CRR Future Credit Exposure Weighting Factors

DC Energy Comments

CRR FCE Weighting Factors – Executive Summary –

Company X's November 2006 6-month Portfolio – FCE under ERCOT Initial Proposal and DCE Proposal –

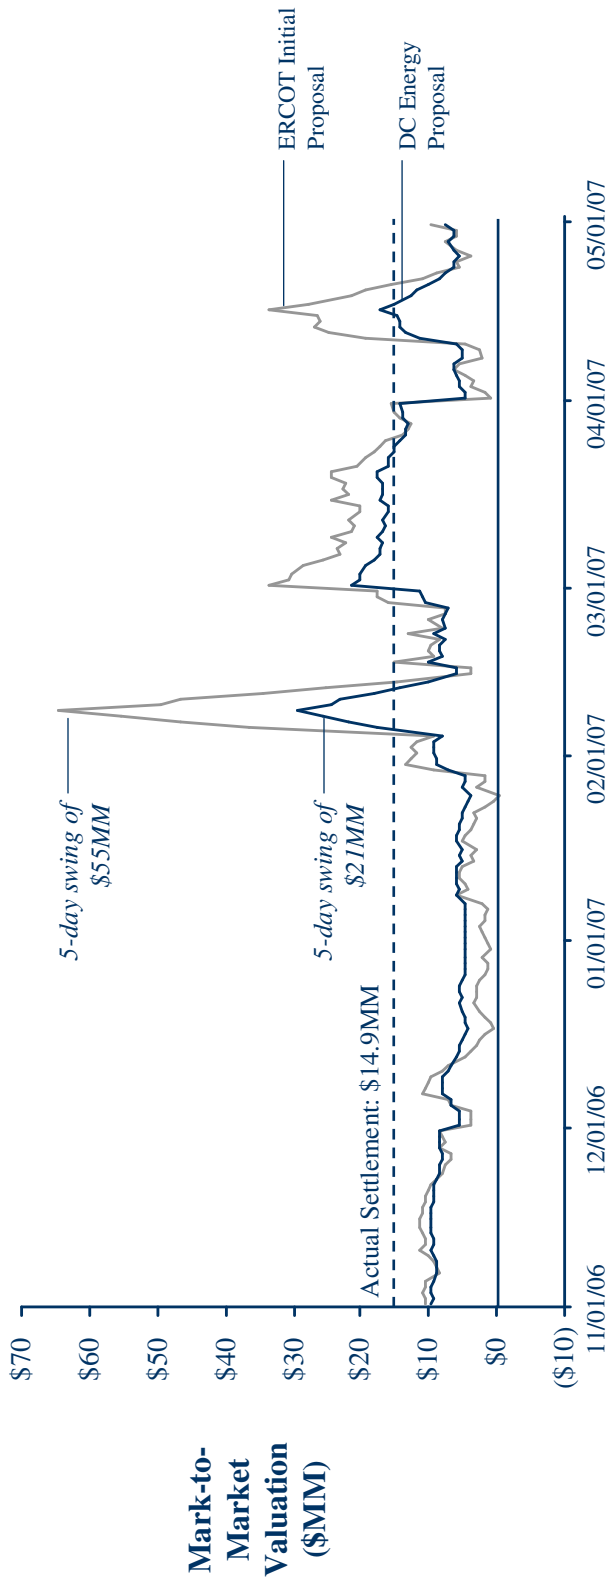
DC Energy's proposed weights reduces the short term mark-to-market valuation during short term price spike events to modest levels

NYISO November 2006 6-Month Auction
 -- Mark-to-Market Valuation Standard Deviation --

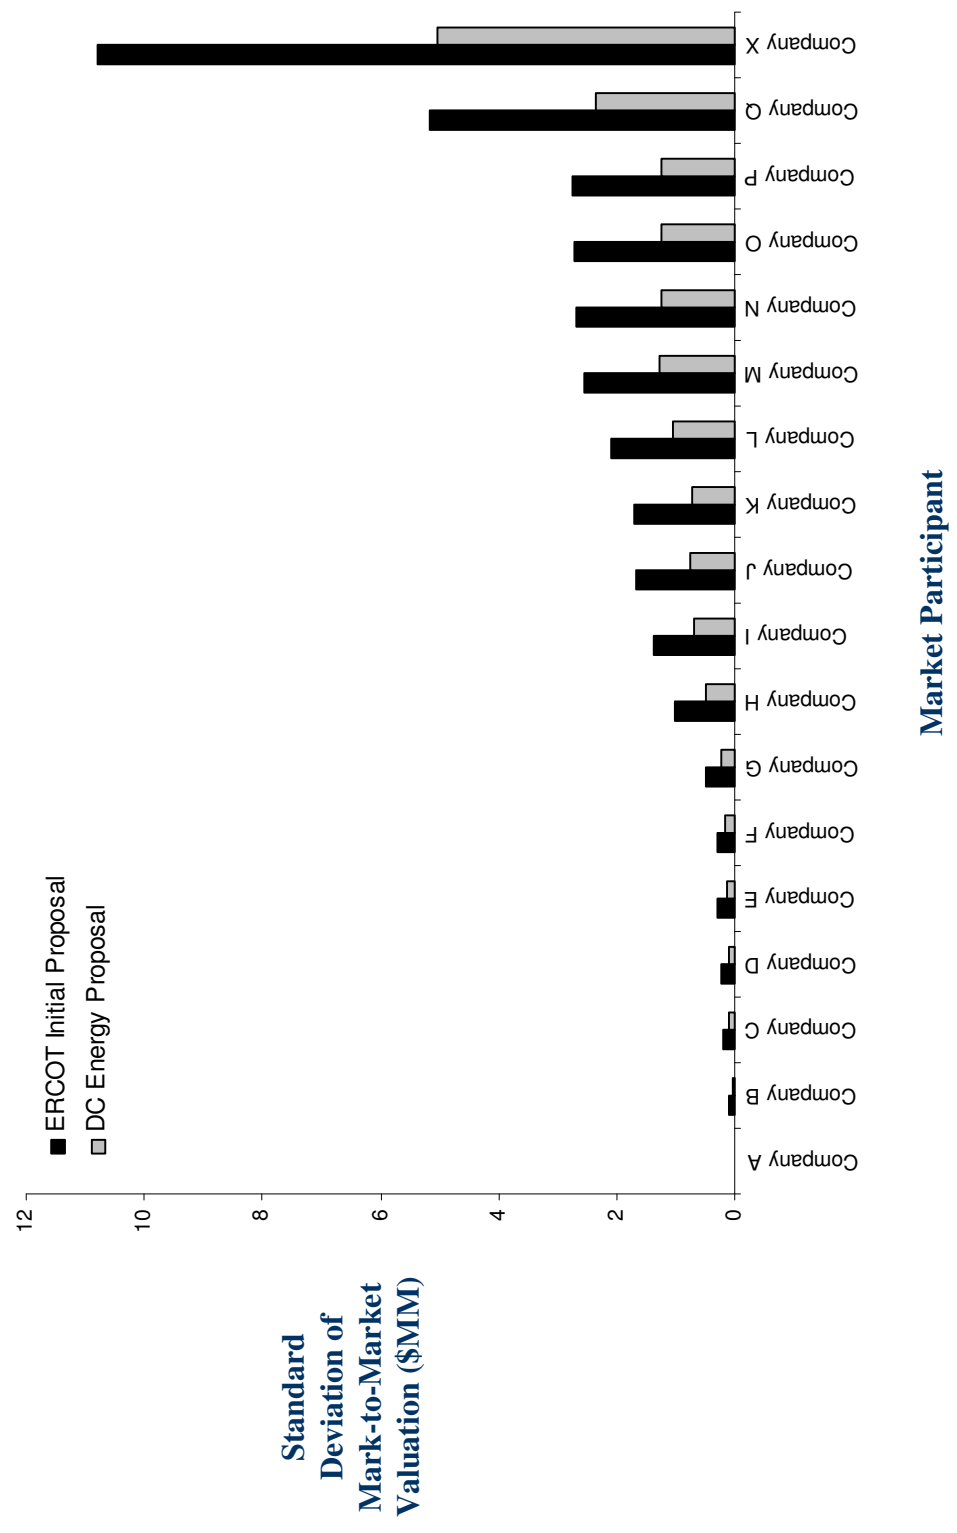
DC Energy's proposal for weights significantly reduces the volatility of the mark-to-market valuation at the portfolio level

NYISO November 2006 6-Month Auction
– FCE Under-Collateralization, Negative Portfolios –

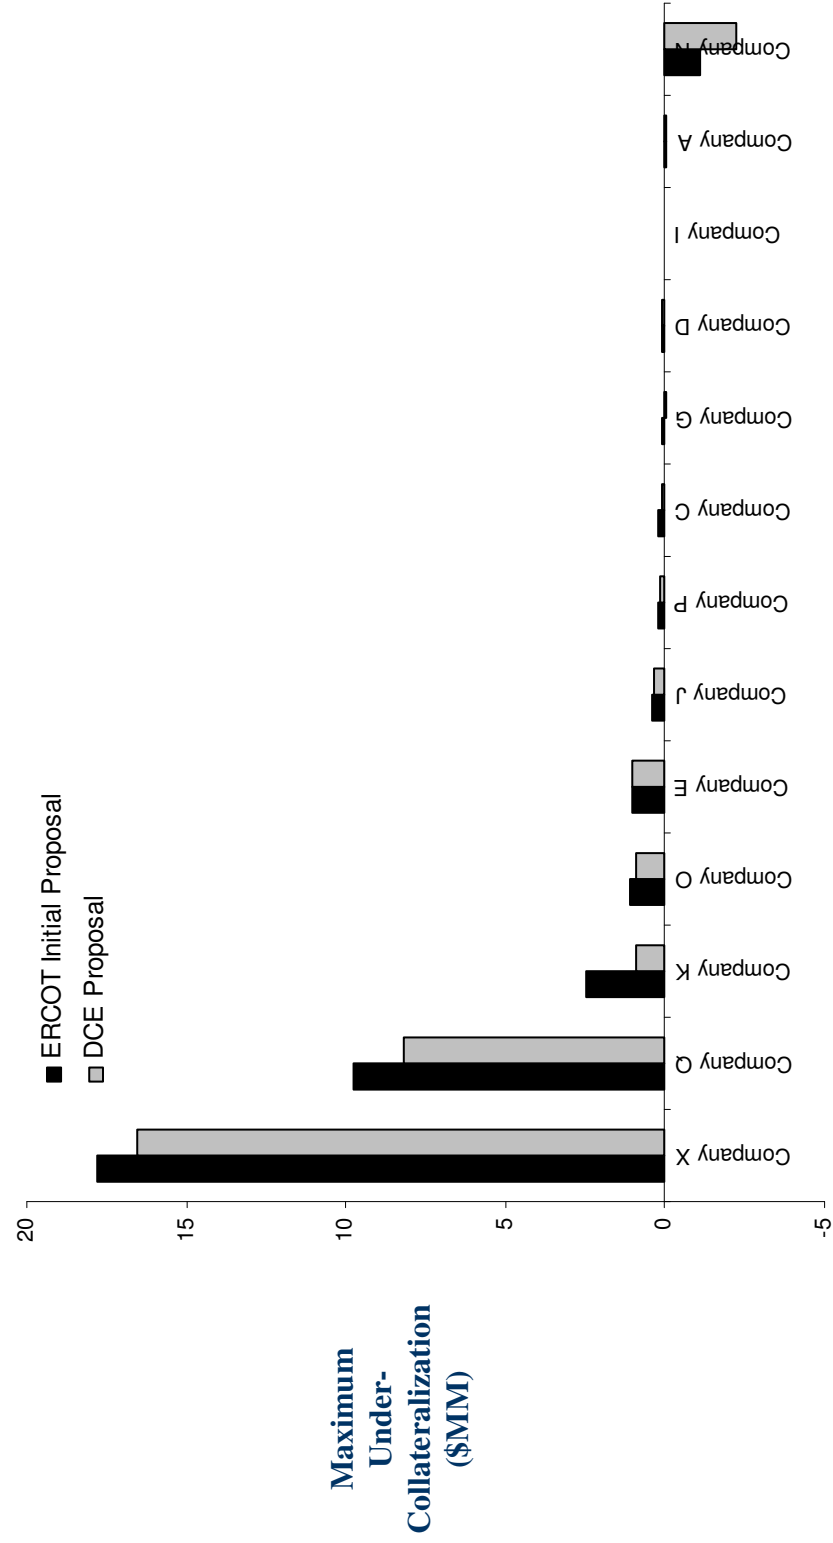
DC Energy's proposal for weights in all cases has lower maximum under-collateralization for the negatively priced portfolios of market participants
